BLUE CREEK COAL SALES INC. SUBDIVISION

APPLICATION NUMBER 7 DATE September 5, 2013
APPLICANT Blue Creek Coal Sales, Inc. Subdivision
REQUEST Subdivision

DETAIL SITE PLAN

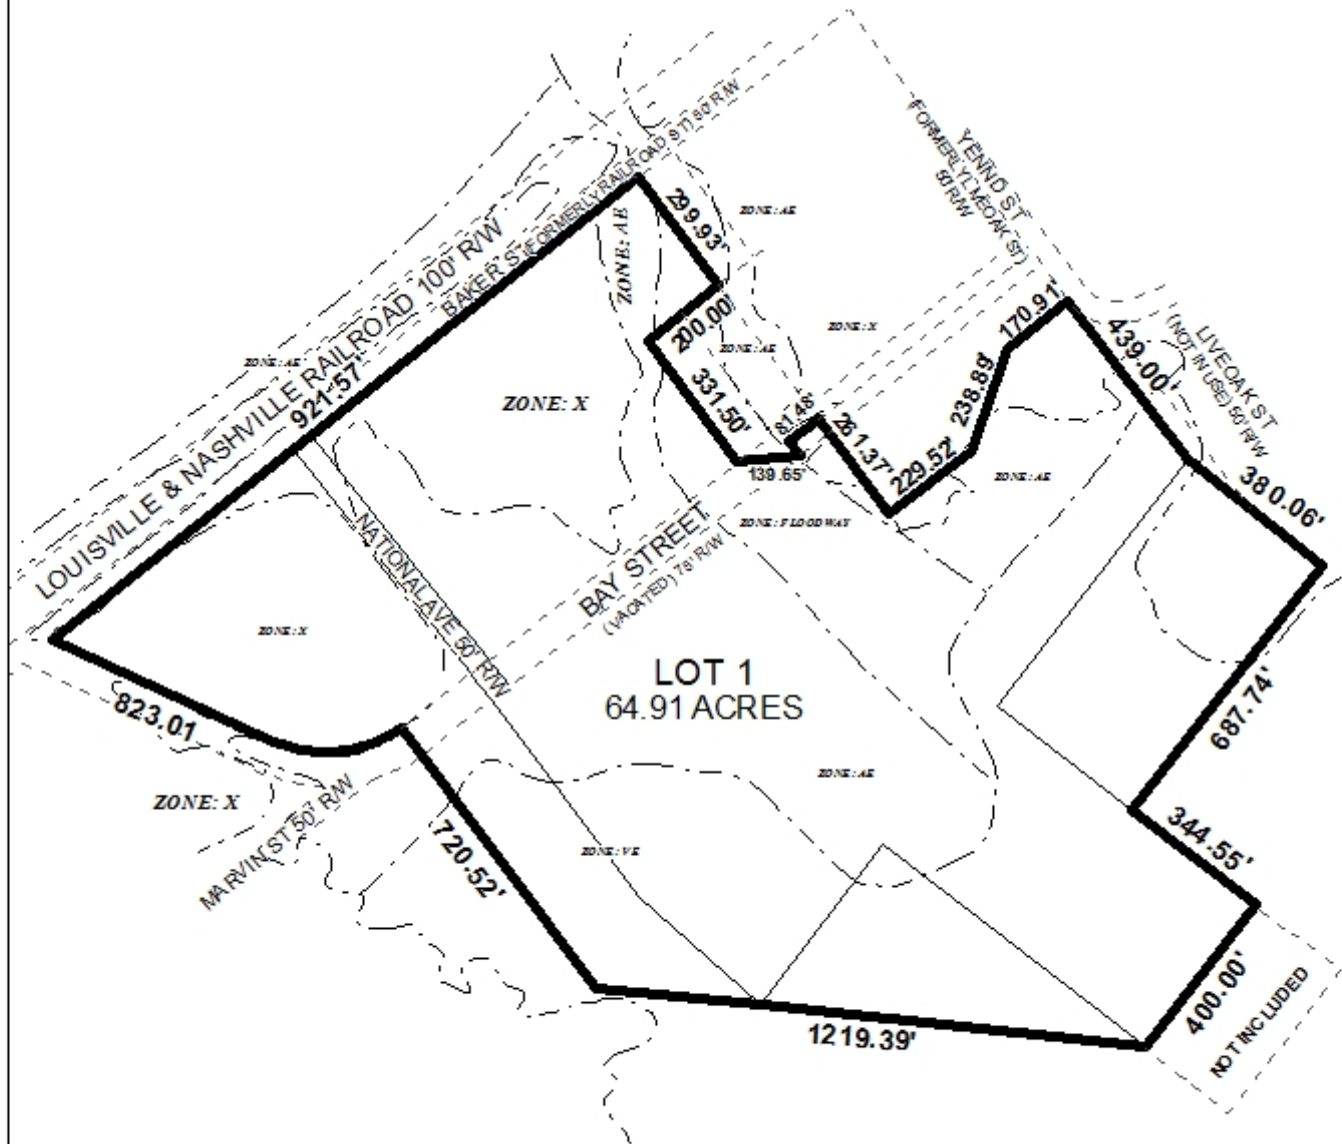
- 1) Provide the signatures for the Owner (notarized), Surveyor, Planning Commission and Traffic Engineer.
- 2) Show and label the MFFE (Minimum Finished Floor Elevation) for LOT 1.
- 3) Add a note to the Plat stating that any development within LOT 1, due to the existing drainage outfall systems that flow through this property, will require a Flood Study.
- 4) Placement of a note on the Plat stating that the approval of all applicable federal, state, and local agencies (including all stormwater runoff, wetland and floodplain requirements) would be required prior to the issuance of a permit for any land disturbance activity;
- 5) Any areas receiving drainage from a public street will require a drainage easement; the width and alignment of the required easement shall be coordinated with, and approved by, the City Engineer.

Traffic Engineering Comments: Driveway number, size, location and design to be approved by Traffic Engineering and conform to AASHTO standards.

- 1) Compliance with Engineering comments (*The following comments should be addressed prior to acceptance and signature by the City Engineer: 1) Provide the signatures for the Owner (notarized), Surveyor, Planning Commission and Traffic Engineer. 2) Show and label the MFFE (Minimum Finished Floor Elevation) for LOT 1. 3) Add a note to the Plat stating that any development within LOT 1, due to the existing drainage outfall systems that flow through this property, will require a Flood Study. 4) Placement of a note on the Plat stating that the approval of all applicable federal, state, and local agencies (including all stormwater runoff, wetland and floodplain requirements) would be required prior to the issuance of a permit for any land disturbance activity; 5) Any areas receiving drainage from a public street will require a drainage easement; the width and alignment of the required easement shall be coordinated with, and approved by, the City Engineer.*);

- 2) Compliance with Traffic Engineering comments (*Driveway number, size, location and design to be approved by Traffic Engineering and conform to AASHTO standards.*);
